ADDENDUM # 1 Questions and Clarifications

Administration Building HVAC Renovation IFB #FED2019-02

**Greater Peoria Mass Transit District (GPMTD/CityLink)
Administration Building HVAC Renovation**

Addendum 01

Sheet M1.2 – ROOF MECHANICAL PLAN

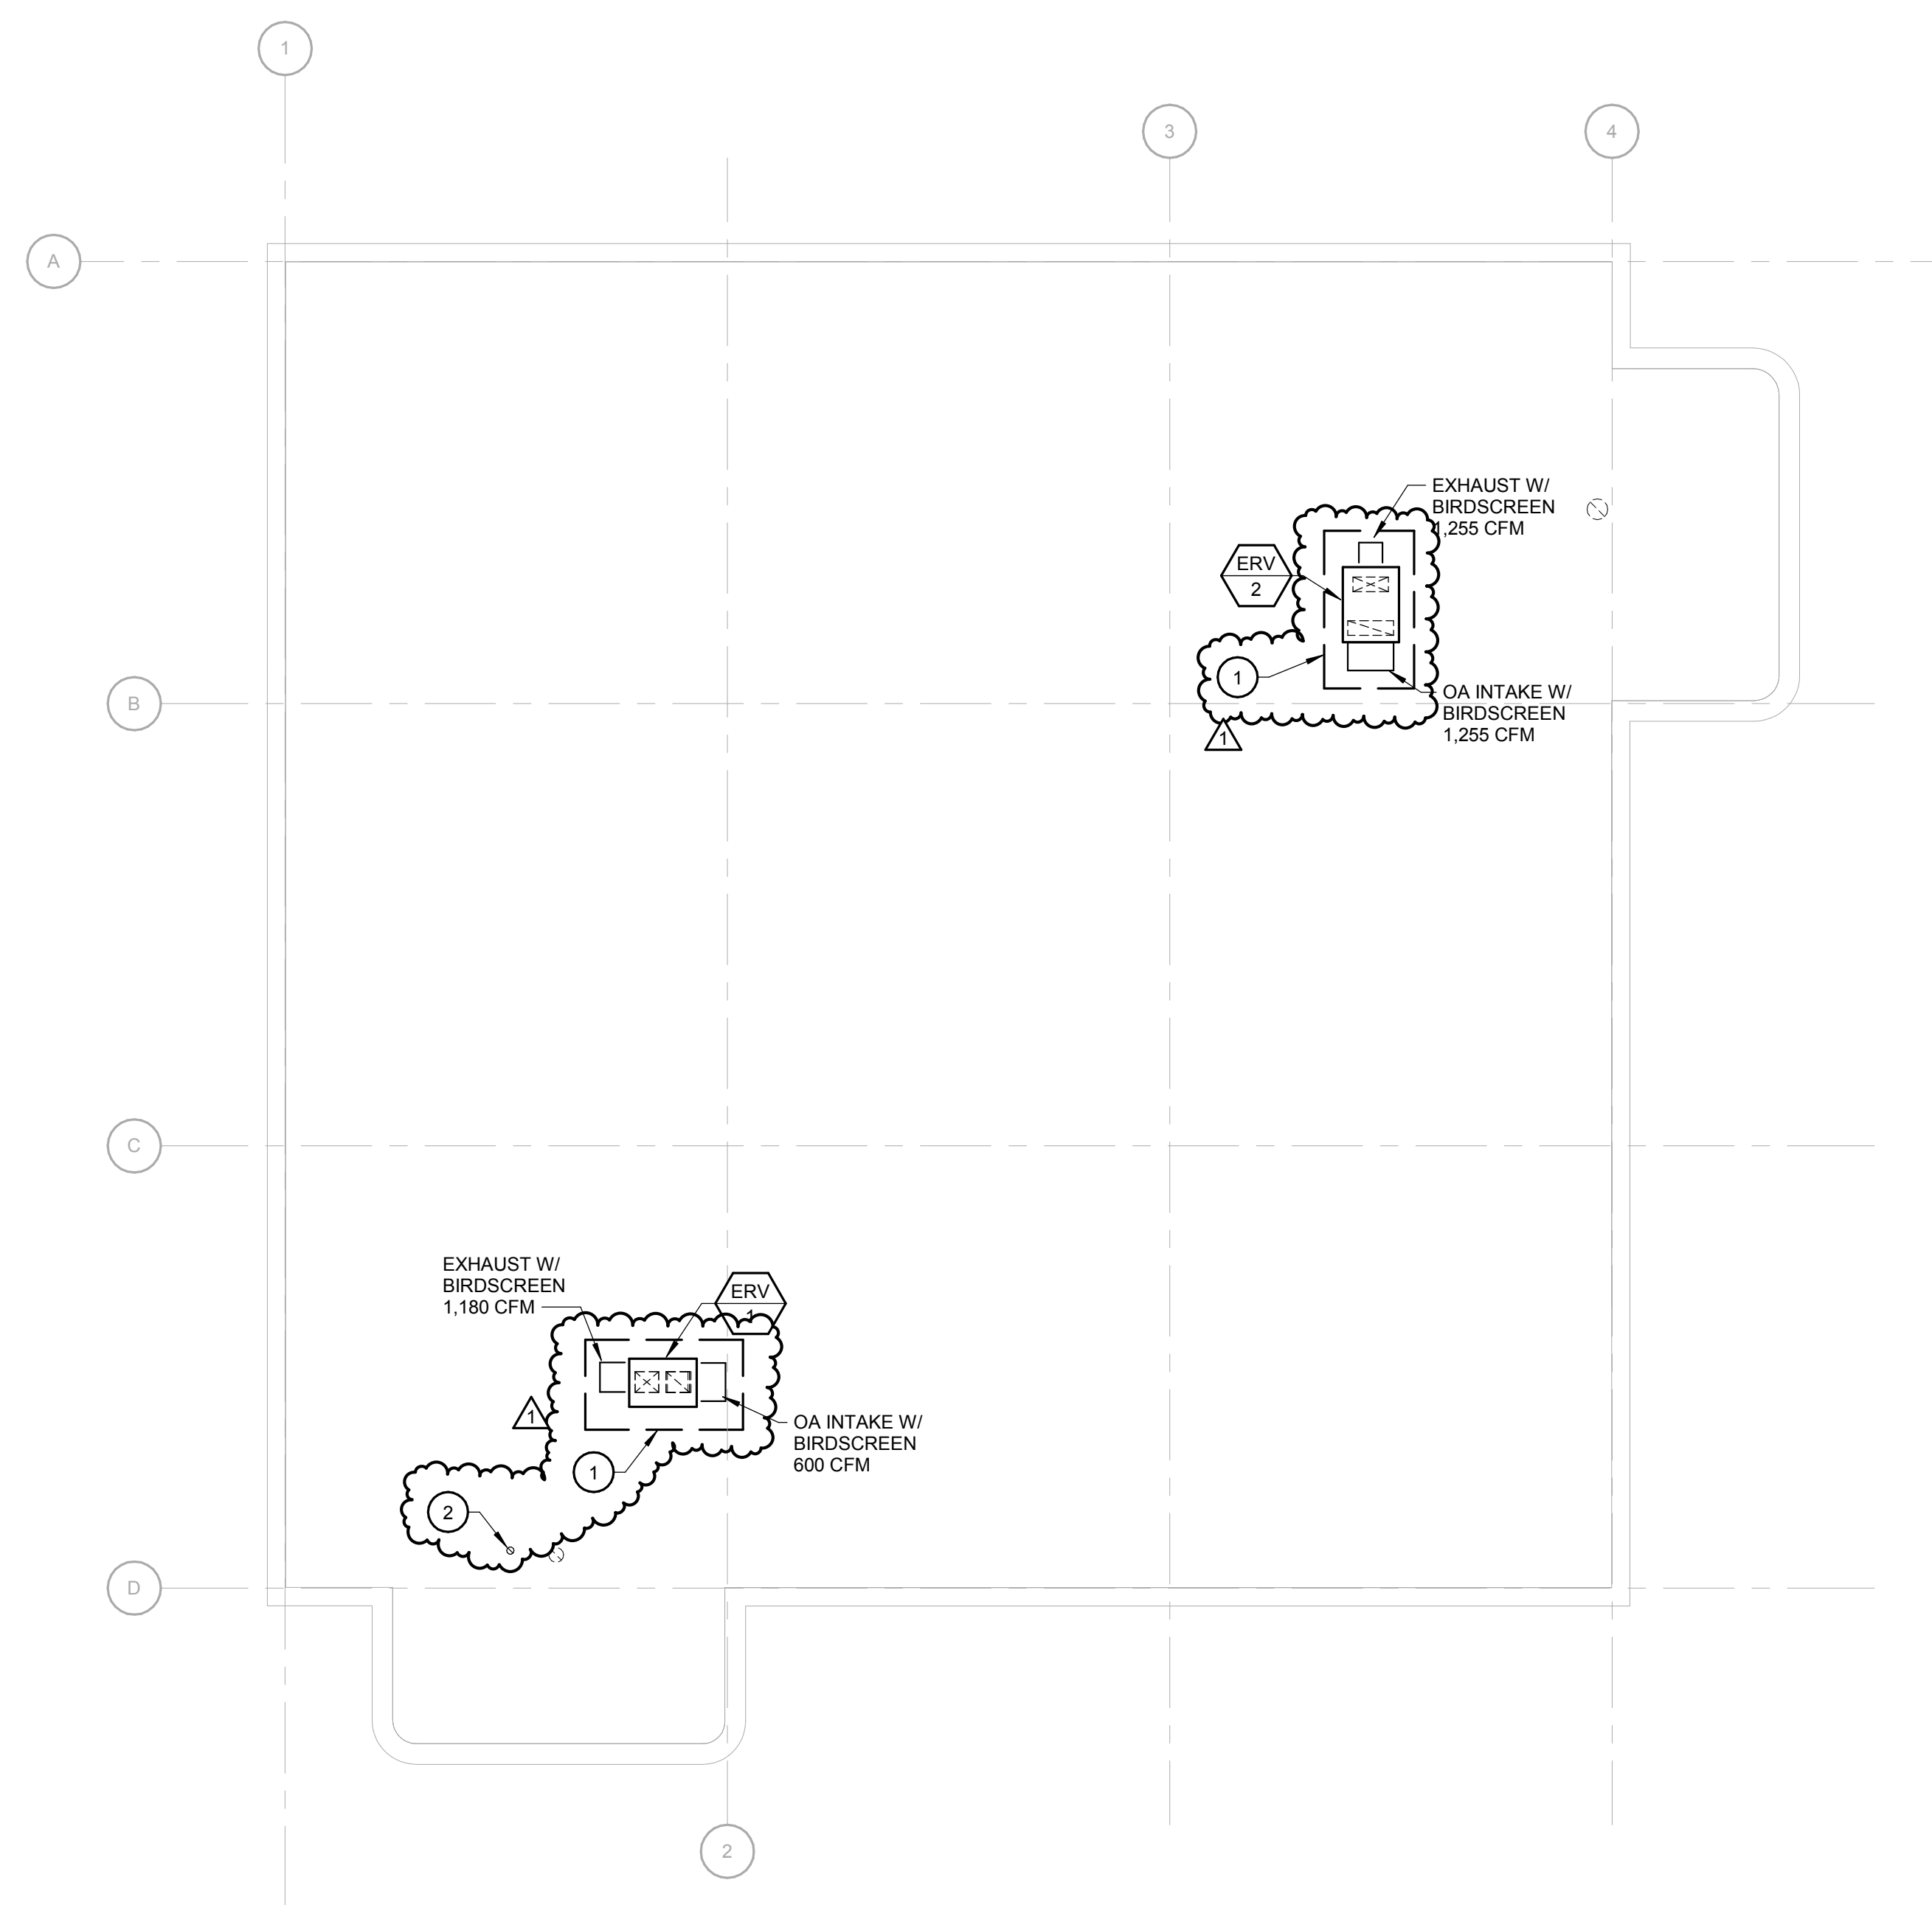
1. REVISION: Revise Roof Mechanical Plan per attached M1.2.
2. REVISION: Added Keynotes 1 and 2 and associated scope.

- PROVIDE EQUIPMENT CURB MOUNTED ROOF SCREEN OF SUFFICIENT HEIGHT TO SCREEN ERV. BASIS OF DESIGN SCREEN IS CITYSCAPE ENVISOR WITH ACRYLIC CAP VERTICAL LOUVER PANELS, BAND TRIM, AND COLOR AS SELECTED BY ARCHITECT.
- 5"Ø FLUE THROUGH ROOF. TERMINATE WITH RAIN CAP.
